2275 Corbett Canyon Road
San Luis Obispo, CA 93401

July 11, 2011

Re: Comments on Cold Canyon Landfill Expansion Recirculated Draft EIR

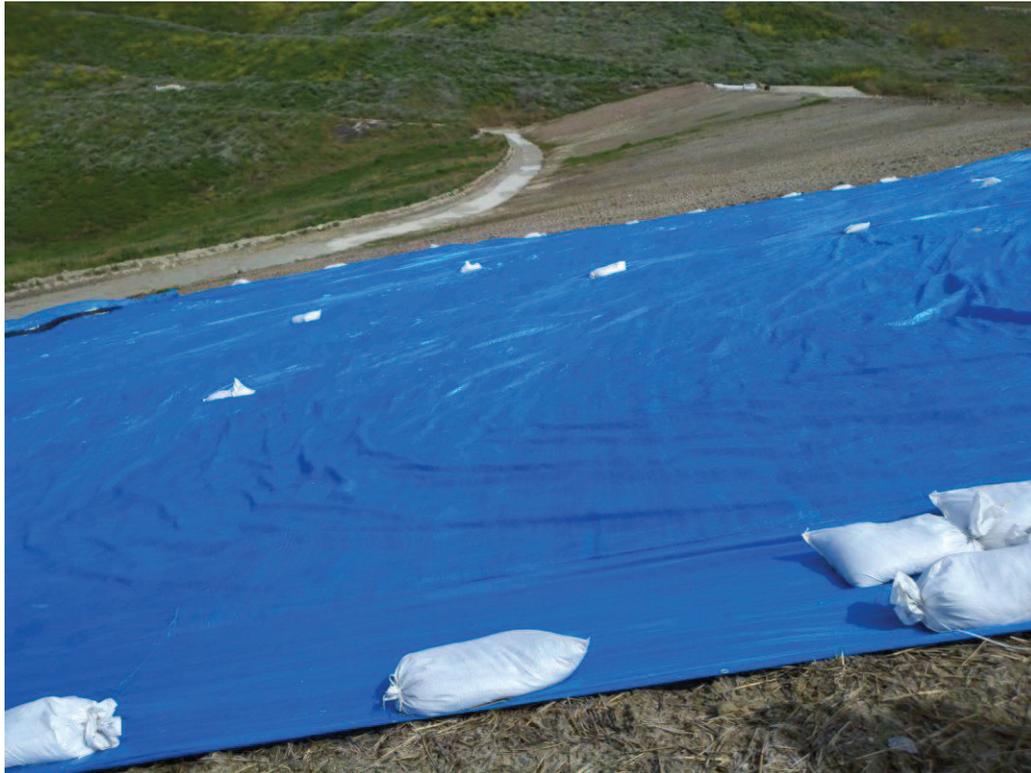
Photo 13, 14, & 15 – Landfill Bench Above the Interior Holding Pond: Most benches continue to be unlined and have eroded drainageways. Poned seeps observed along bench. Commented to landfill staff that several seeps appeared to result from the drainages having eroded and cut into the slope. **Violation:** WDR Specification C.11 requires that drainageways over waste be lined.

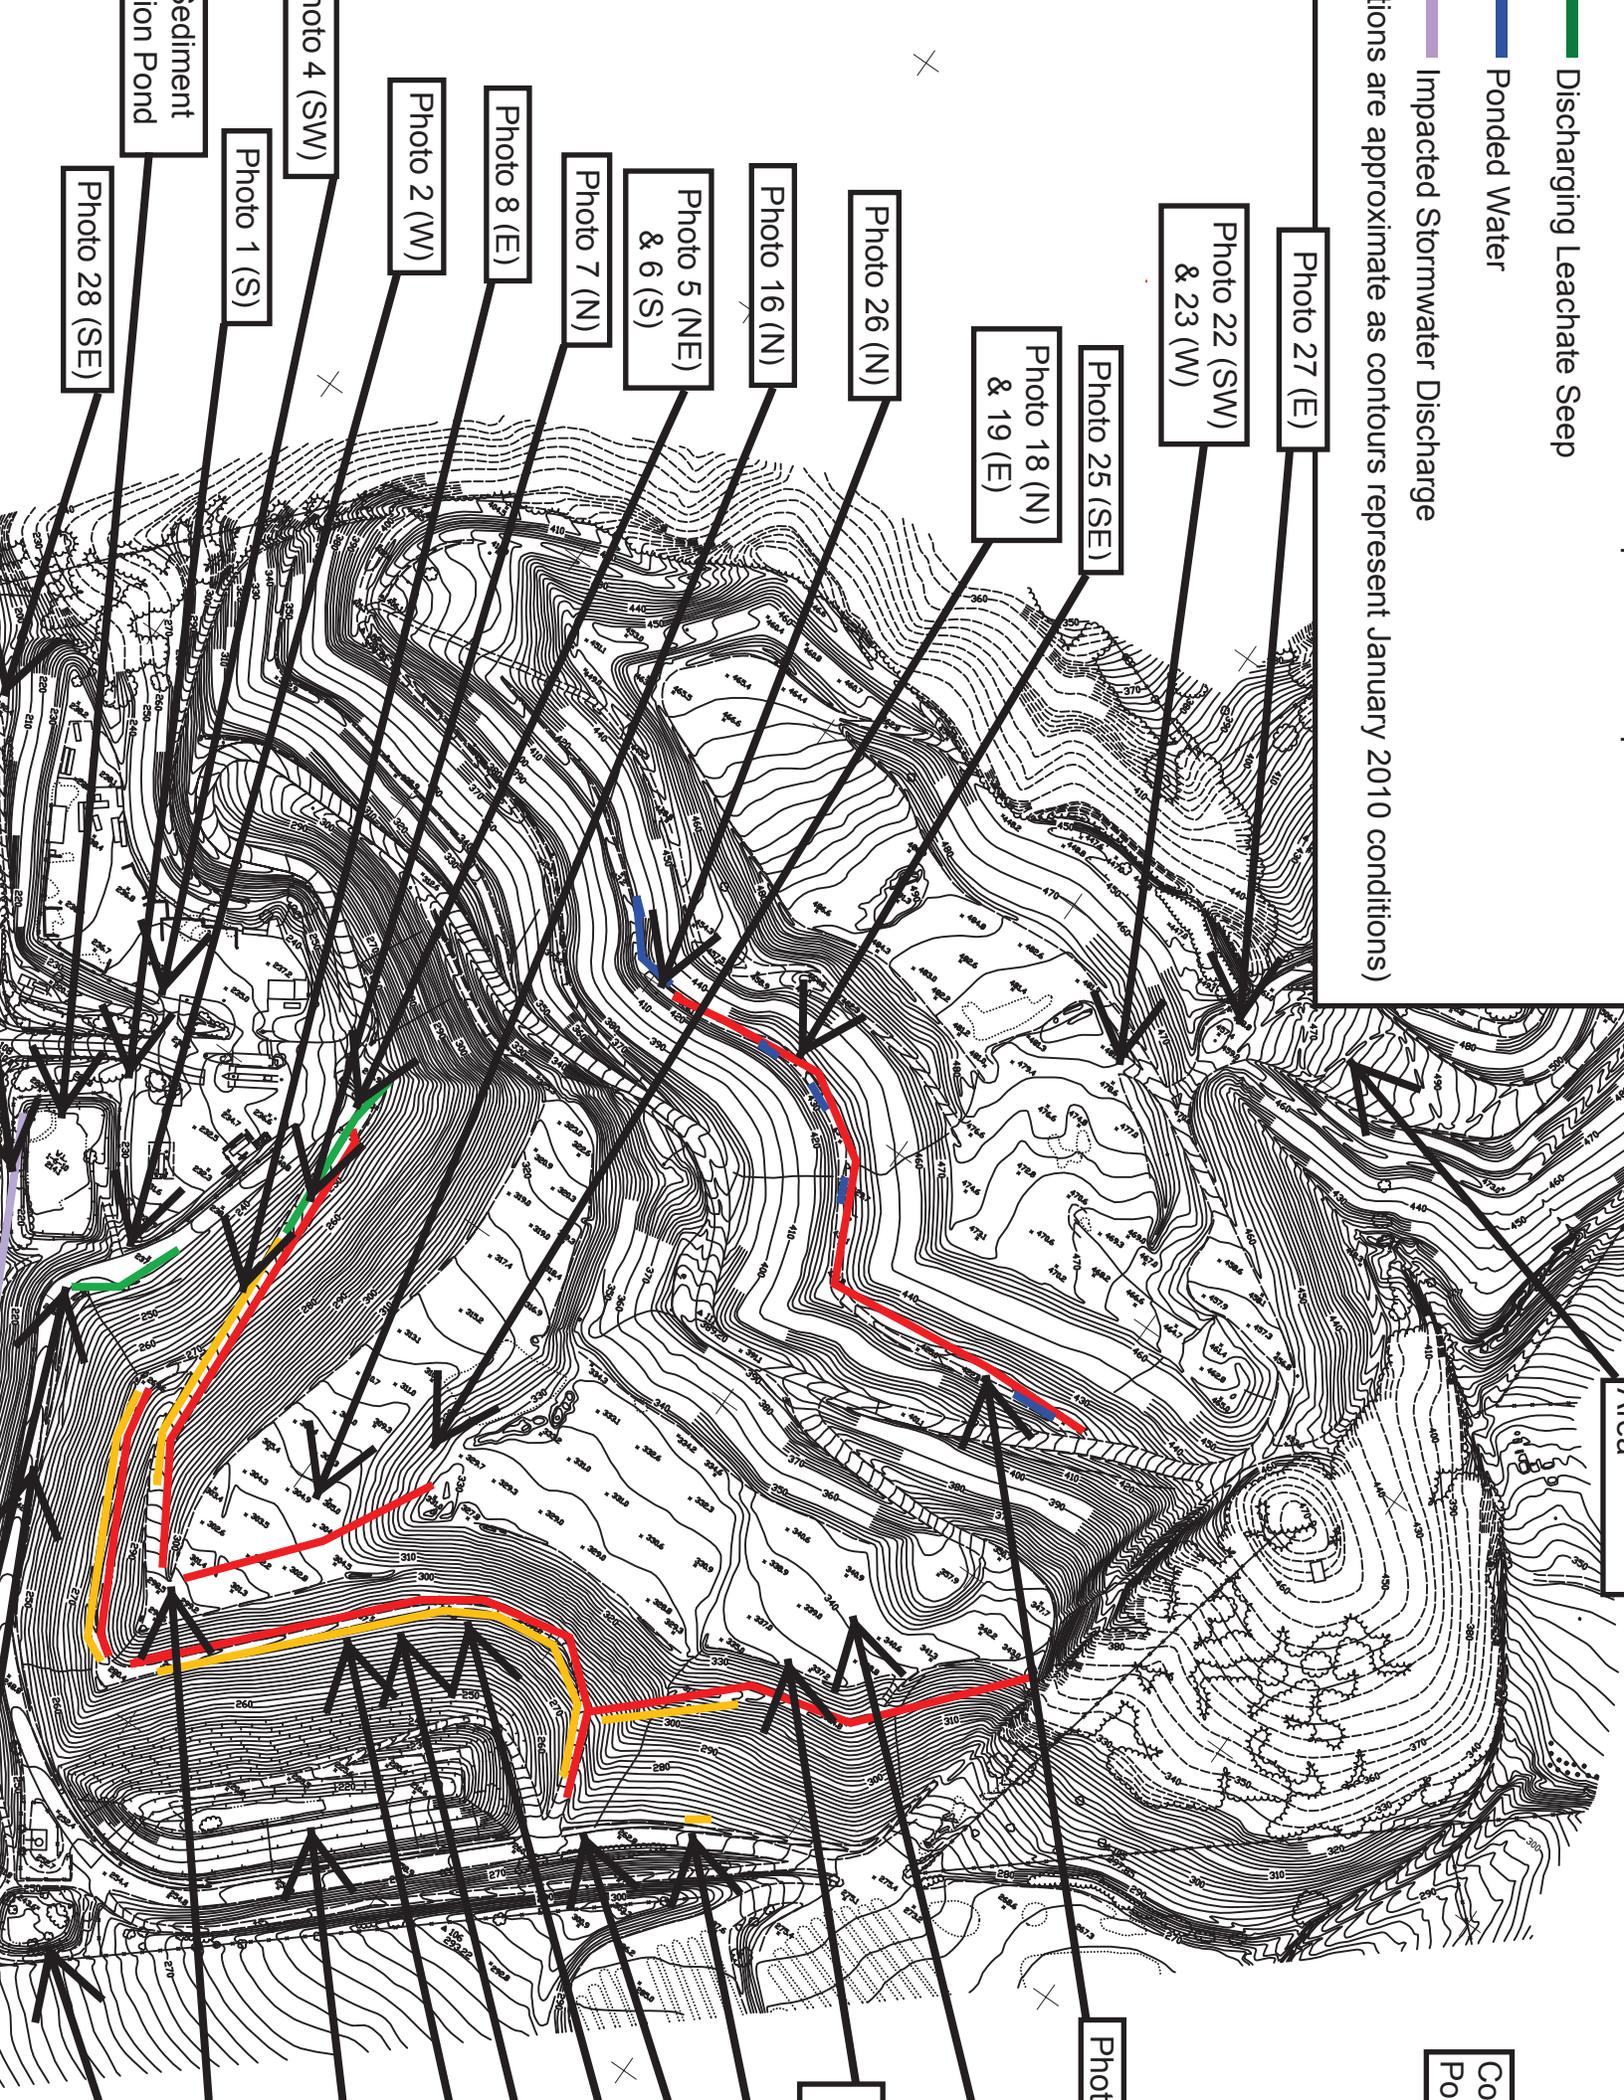
Impacted Stormwater Discharge
